## Hoffmann Drilling Pty Ltd Superannuation Fund v Gold Coast City Council & Ors

### Planning and Environment Court Appeal No 137 of 2020

Joint Expert Report on groundwater issues between the following:

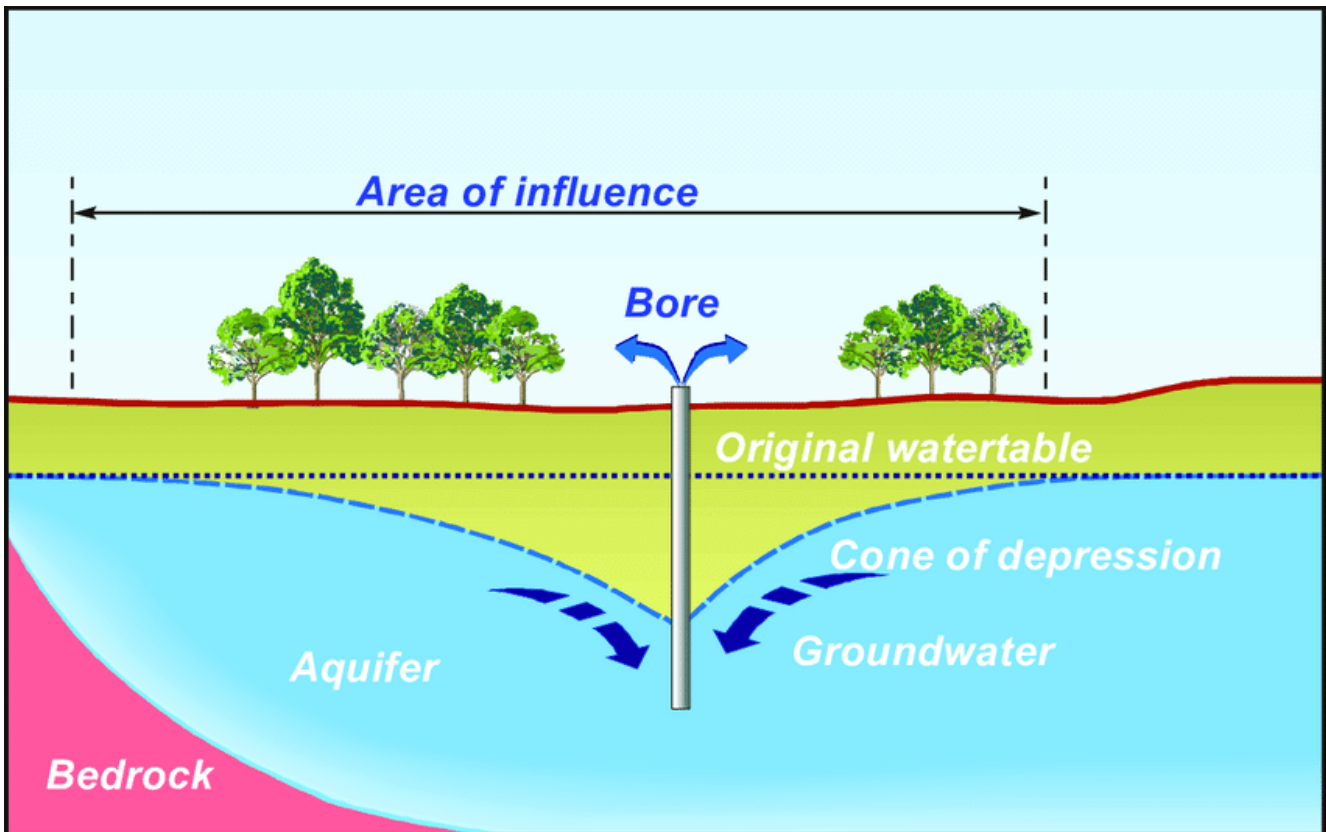
- (f) The description and visual depiction of a drawdown cone in TJ's report may not be appropriate for the site, as the aquifer in question is a fractured rock aquifer, and is thus likely to exhibit heterogeneity and/or anisotropy (i.e., not simple, radial patterns of drawdown in response to groundwater extraction).

- (22) TJ says, in response to the points raised by MC above, that there can be no adverse impact on either springs or GDEs if these features lie outside of the cone of depression formed in the groundwater surface when pumping occur. TJ says that the definition of the cone of depression is that there is no change to groundwater levels or conditions outside of the boundary of the cone. The only question which needs to be considered is whether the nominated features (springs and GDEs) lie outside of that zone of influence. TJ says that the information derived from the pump tests is adequate for him to conclude that this is the case.
